PLANNING AND ZONING PACKET

Planning & Zoning AGENDA
Regular Meeting: Monday, March 7, 2022

Preliminary Plat
for
KOKOMO SUBDIVISION
ROCKPORT, Texas

KOKOMO SUBDIVISION, PHASE II

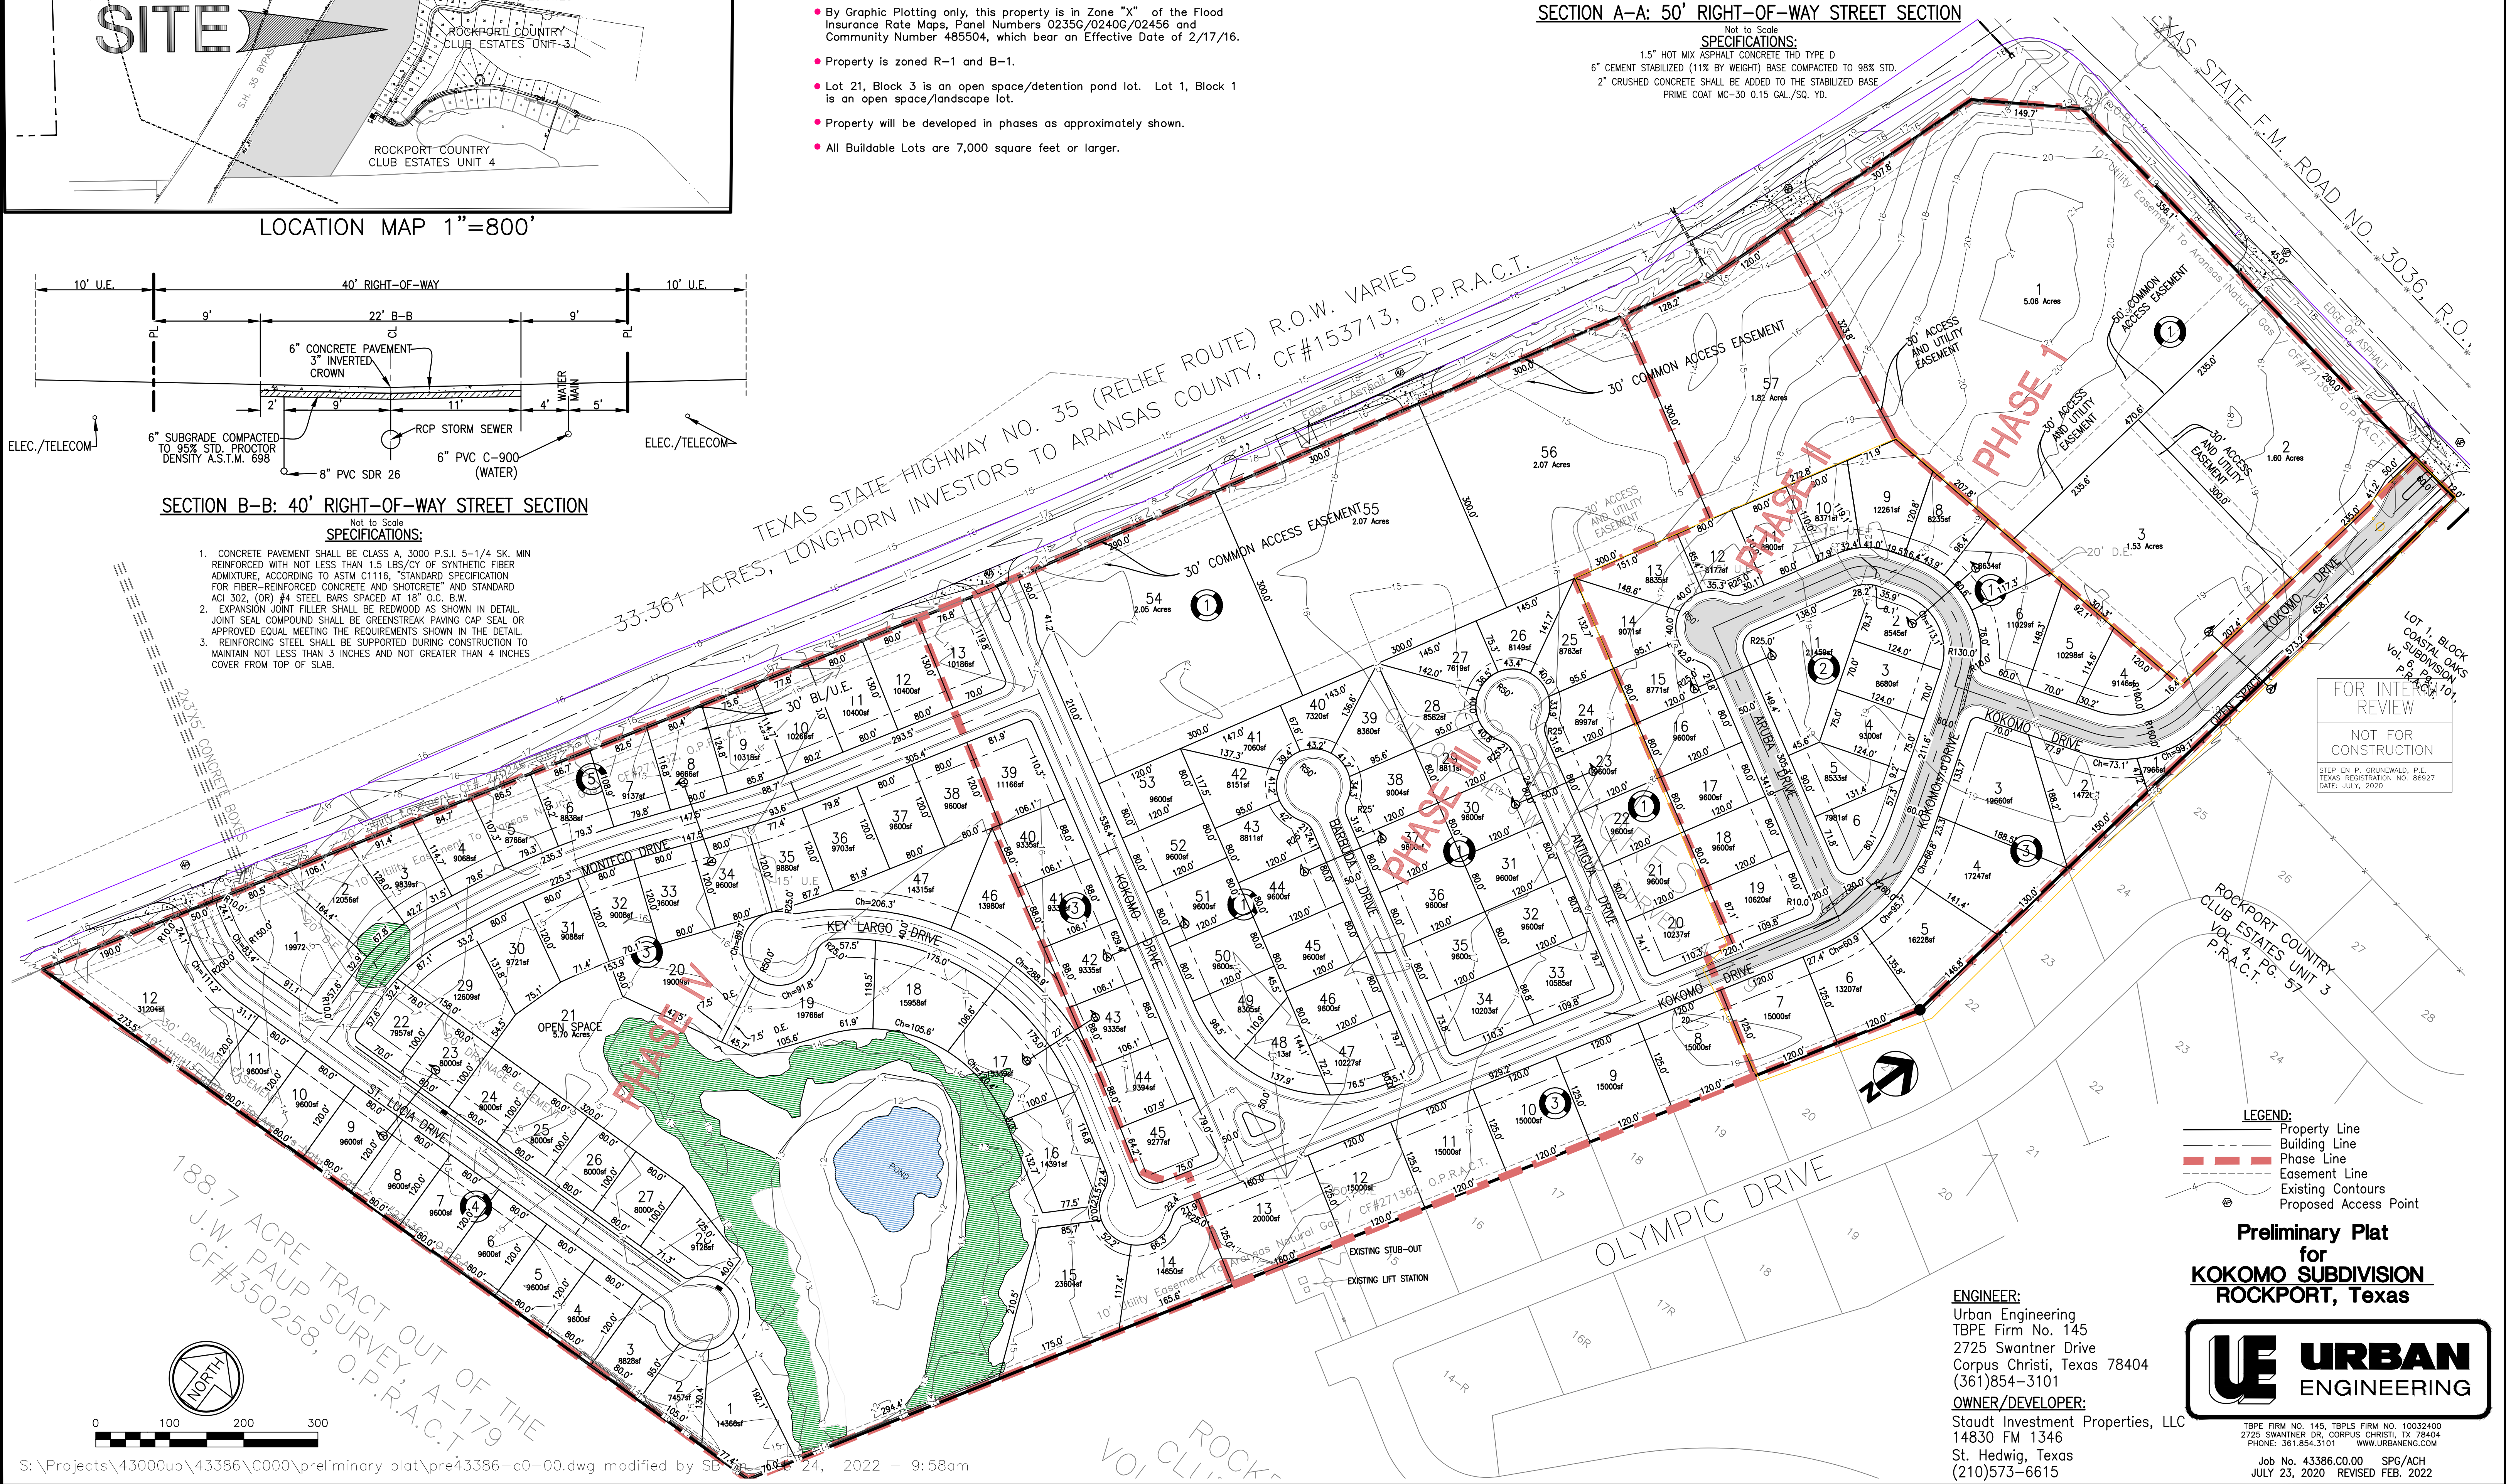
BACKGROUND: Staudt Investment Properties, LLC have submitted a Revised Preliminary Plat which modifies the original Preliminary Plat by removing Lots 54, 55, and 56 from Phase II and including Lots 54, 55, and 56 in Phase III

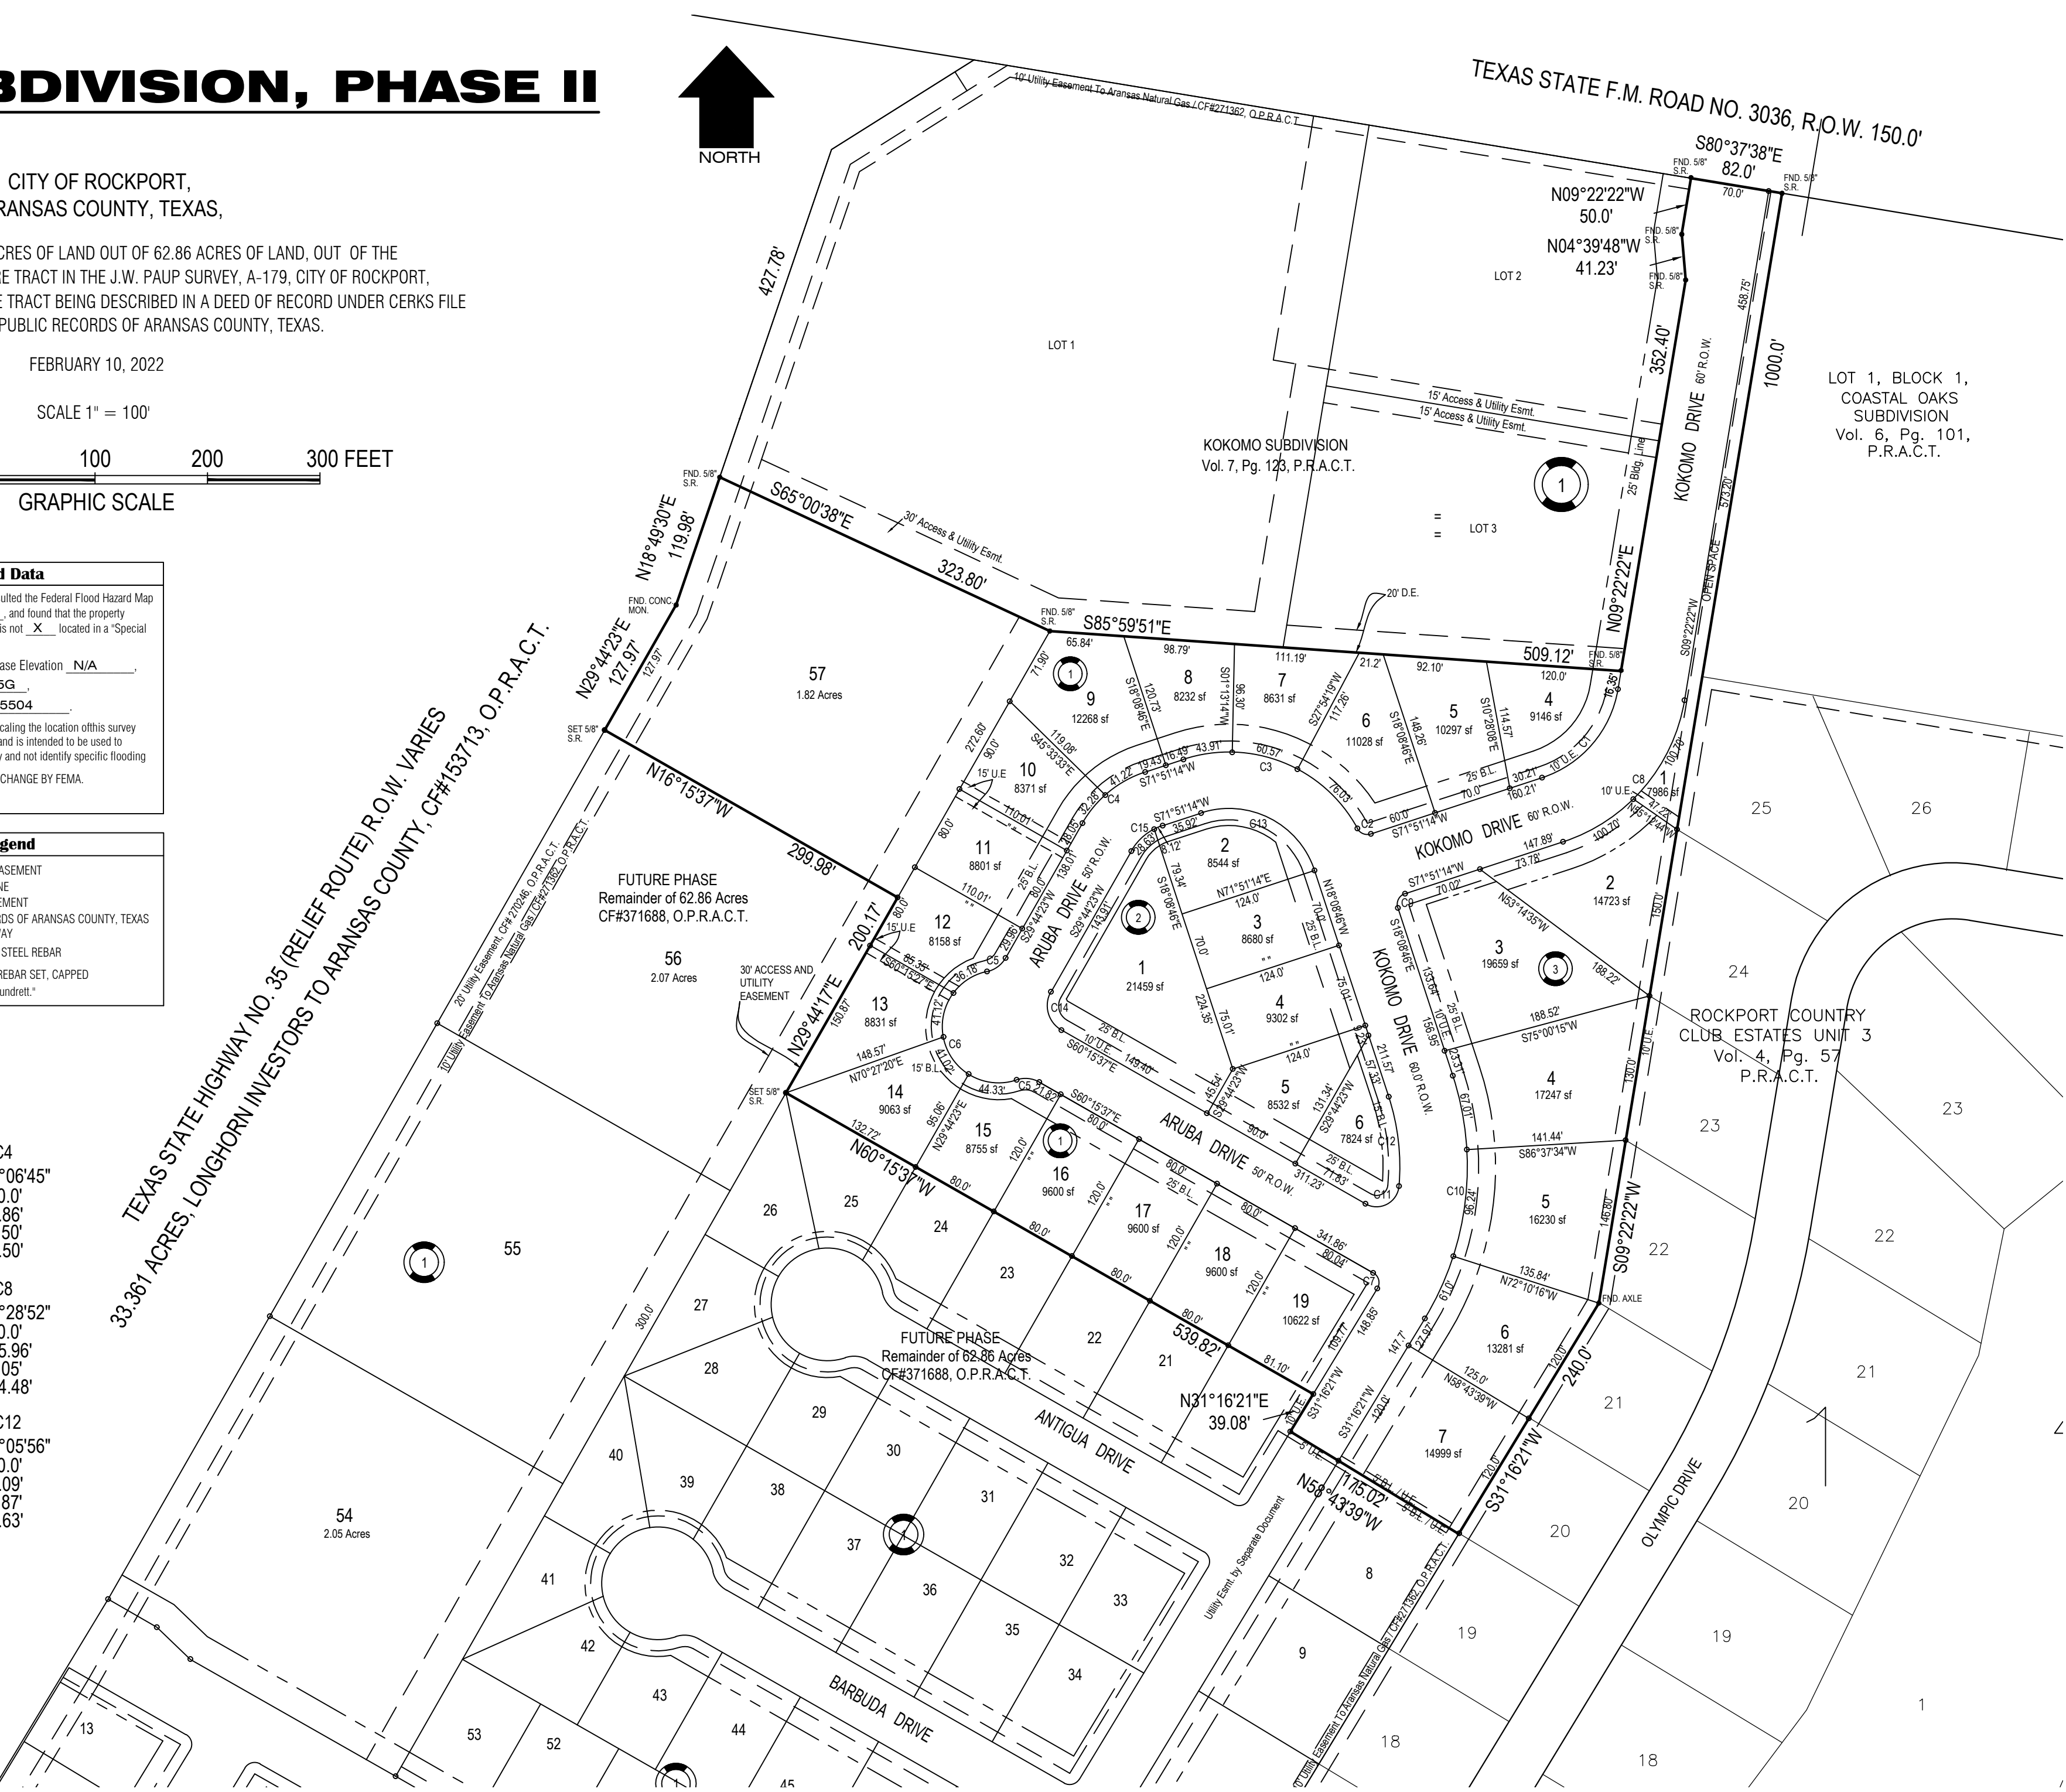
BACKGROUND: Staudt Investment Properties, LLC have submitted a Revised Phase II Final Plat which modifies the original Final Plat by removing Lots 54, 55, and 56 from Phase II Final Plat.
